Graphics Textiles Ltd. (Extension 2)

01 July 2025

2. Observations:

Observation-3: Discrepancies in as-built drawings. [Building- 8 (Printing Building)]

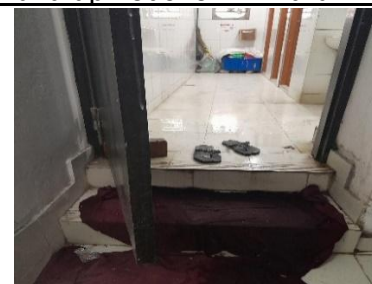
Build up not shown in drawing

On site condition (15 inch build up)

Description: Vertical bracing was found missing at grid location E/2-3. Additionally, the floor buildup on the 1st floor was not reflected in the as-built drawings. Also details of cable bracing (25 mm dia) were not mentioned in drawing. The building engineer is required to survey the full structure and update the as-built drawings to accurately reflect the current site conditions.

Observation 05: Prepared EA report needs to be reviewed. (Building-10 New Dyeing Shed)

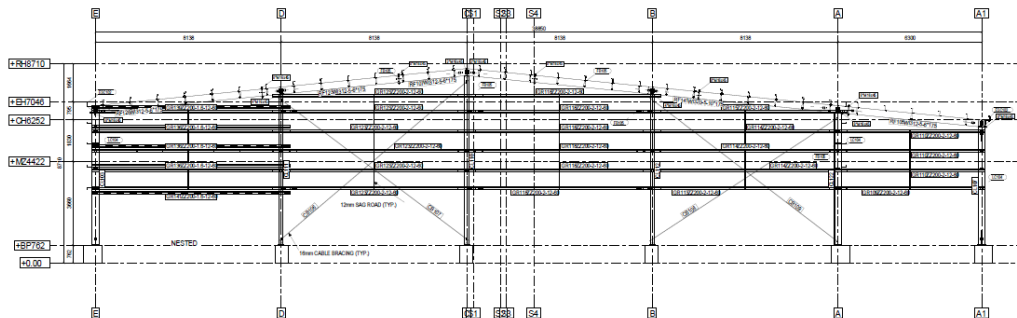
Description: The factory has produced EA report following BNBC 2020. In EA report, compressive strength of concrete has been considered as 3000 psi for beam, column, foundation, but the provided test reports are named Knitting Building. Also, serviceability check was provided only for deflection in wind load case.

The building engineer is required to evaluate concrete strength as per BNBC and submit the design report to RSC for review.

Observation-7: Non-structural elements not anchored or braced. [Building-8 Printing Building, Building-11 Fabric Store Shed A]

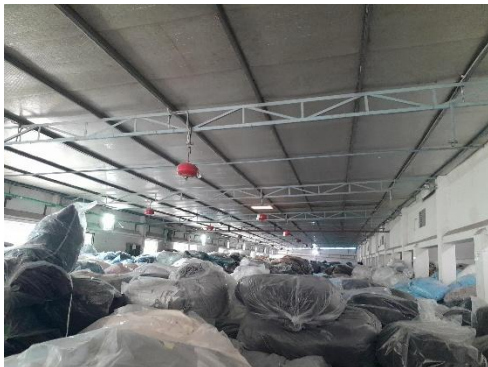
Description: Some racks on floors are not anchored or braced to resist lateral (earthquake) forces. The factory is required to anchor/brace all non-structural elements adequately to resist earthquake forces.

Observation-8: Lack of design report. [Building- 11 Fabric Store Shed A]

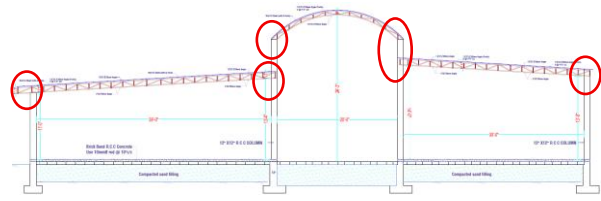
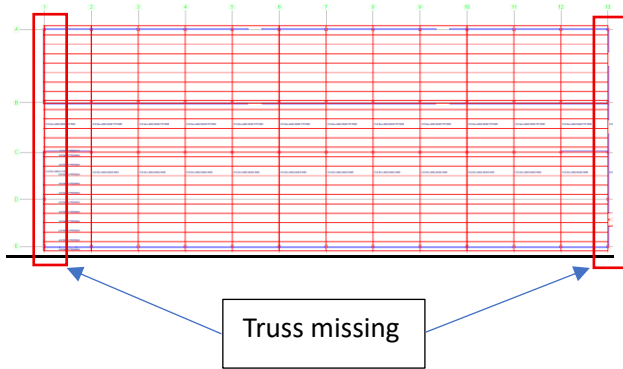
Description: As per BNBC, every building or structure designed shall have its design documents prepared following the provision of Section 1.9.1. The design document shall include a design report, and a set of structural drawings, which shall be prepared in compliance with section 1.9.1.1 and section 1.9.1.2, part 6 of BNBC.

Observation-10: Mismatches in as-built drawing. [Building- 11 Fabric Store Shed A and Building- 12 Fabric Store Shed B]

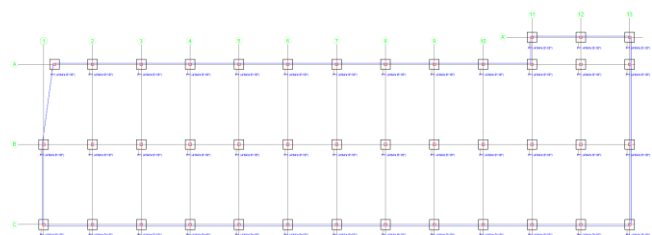
Missing connection details in drawing

Missing connection details in drawing

Description: Truss was found missing at marked area of Building- 11 Fabric Store Shed A and Building- 12 Fabric Store Shed B. Also, grid dimensions and connection details are missing in the as-built drawings of Building 11 Fabric Store Shed A and 12 Fabric Store Shed B. A typical section detail is included in the as-built drawings, but truss is not typical at all grids particularly along the edge grids.

The building engineer is required to conduct a full survey of the structure and revise the as-built drawings to reflect the actual site conditions.

Observation 11: Inconsistencies in as-built drawing (Building-13 Gray Fabric Store Shed A, Building-14 Gray Fabric Store Shed B, Building-15 Gray Fabric Store Shed C, Building-16 Yarn Store Shed, Building-19 Wastage Storage Shed)

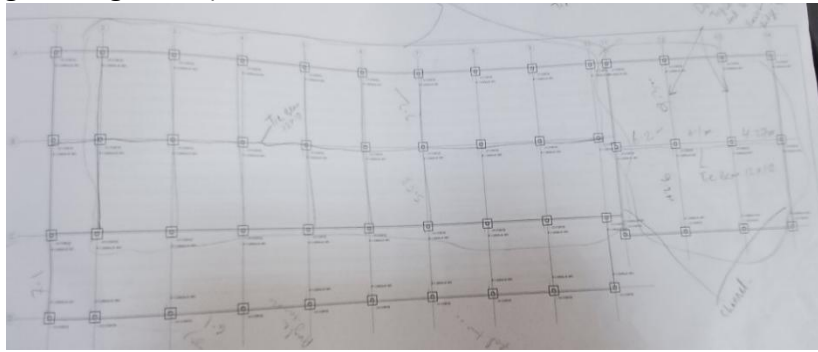
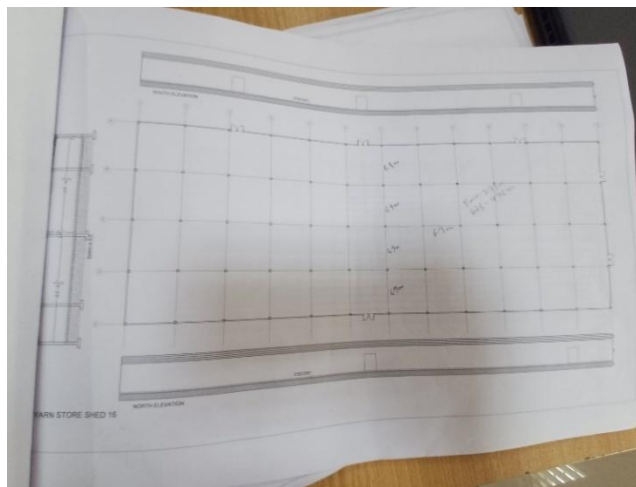
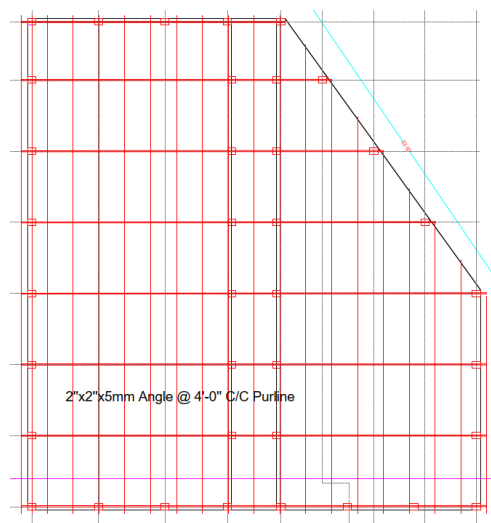
Description: Grid dimensions and connection details are missing in the as-built drawings of Building 13, 14, 15, 16, 17, 18, 19. A typical section detail is included in the as-built drawings, but truss is not typical at all grids particularly along the edge grids.

The building engineer is required to conduct a full survey of the structure and revise the as-built drawings to reflect the actual site conditions.

Observation 12: Mismatches in as-built drawing (Building 17 Yarn & Chemical Store)

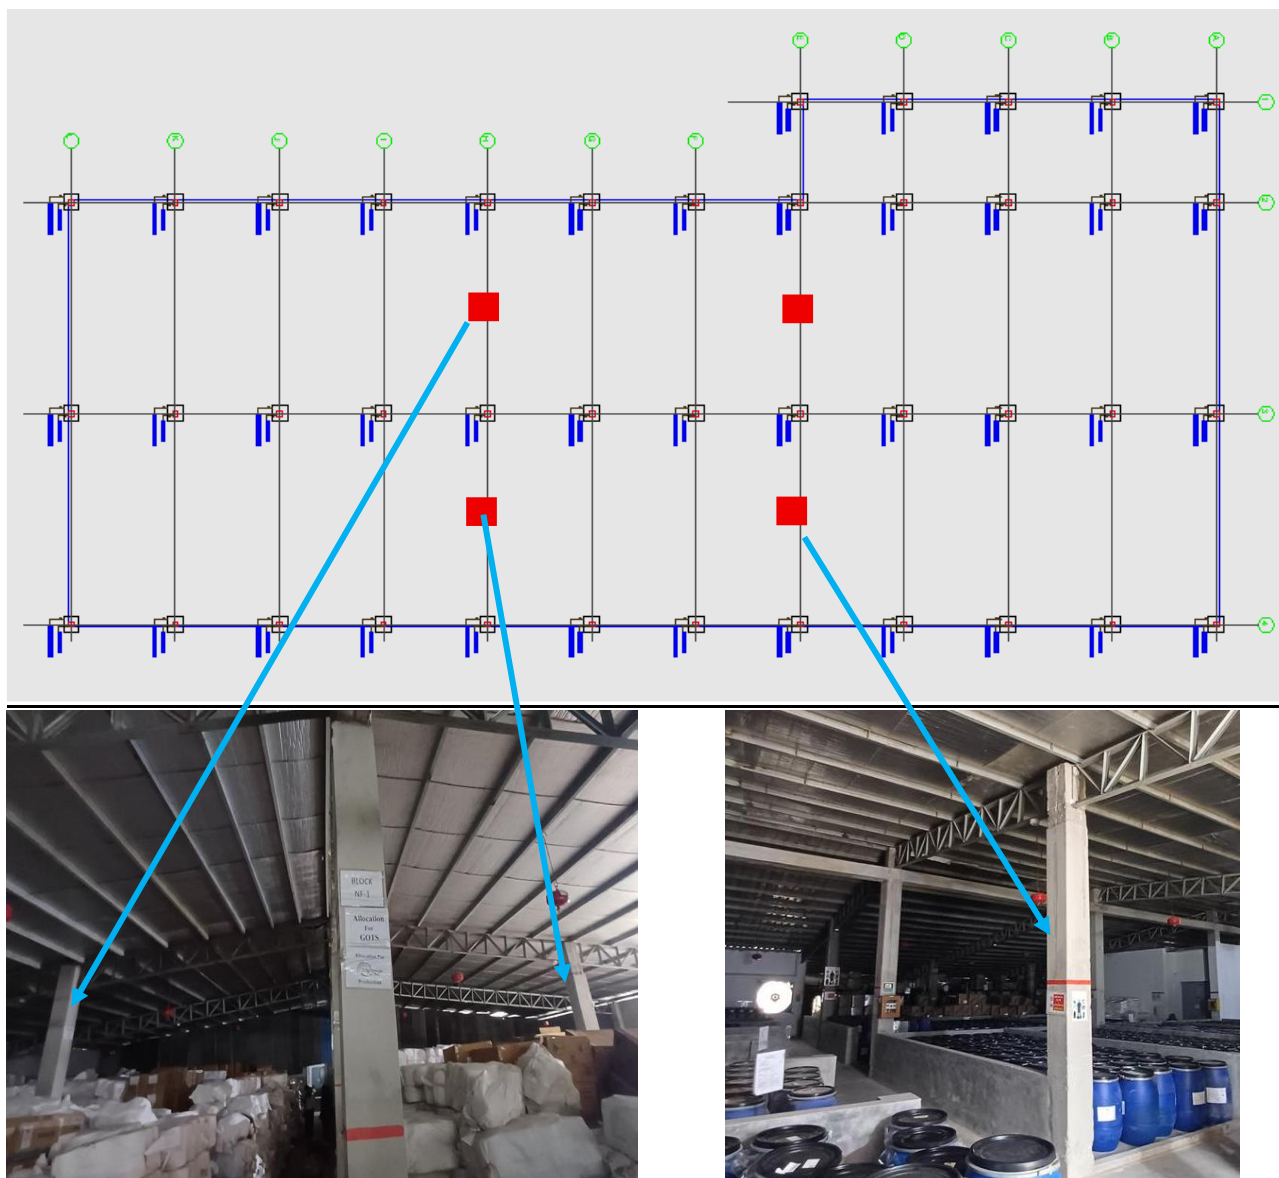
Description: Red marked columns were found onsite but not shown in drawing.

Observation 13: Mismatches in as-built drawing (Building 18 Cartoon Store & Workshop)

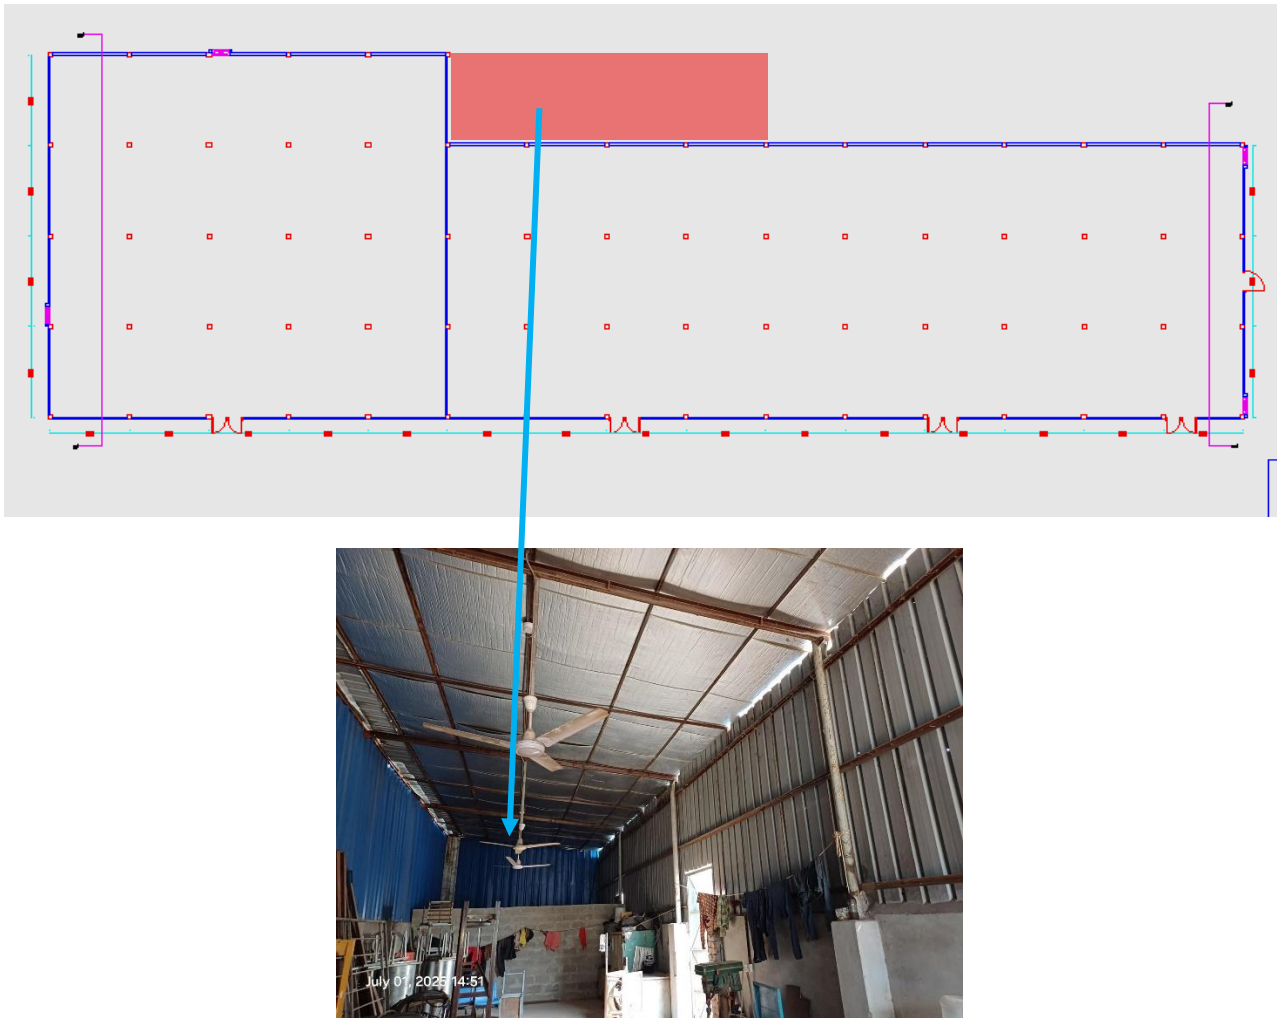
Description: Red marked areas were not shown in drawing.

Observation 14: Lack of design documents (Building-13 Gray Fabric Store Shed A, Building-14 Gray Fabric Store Shed B, Building-15 Gray Fabric Store Shed C, Building-16 Yarn Store Shed, Building-17 Yarn & Chemical Store Shed)

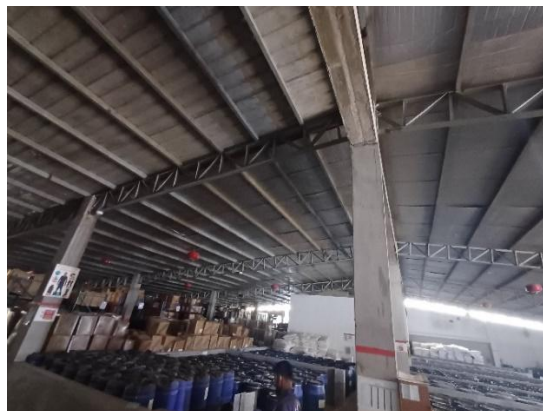
Description: As per BNBC, every building or structure designed shall have its design documents prepared under the provisions of Section 1.9. The design document shall include a design report and a set of structural drawings, which shall be prepared in compliance with section 1.9.2 and section 1.9.3 as per BNBC 2020.
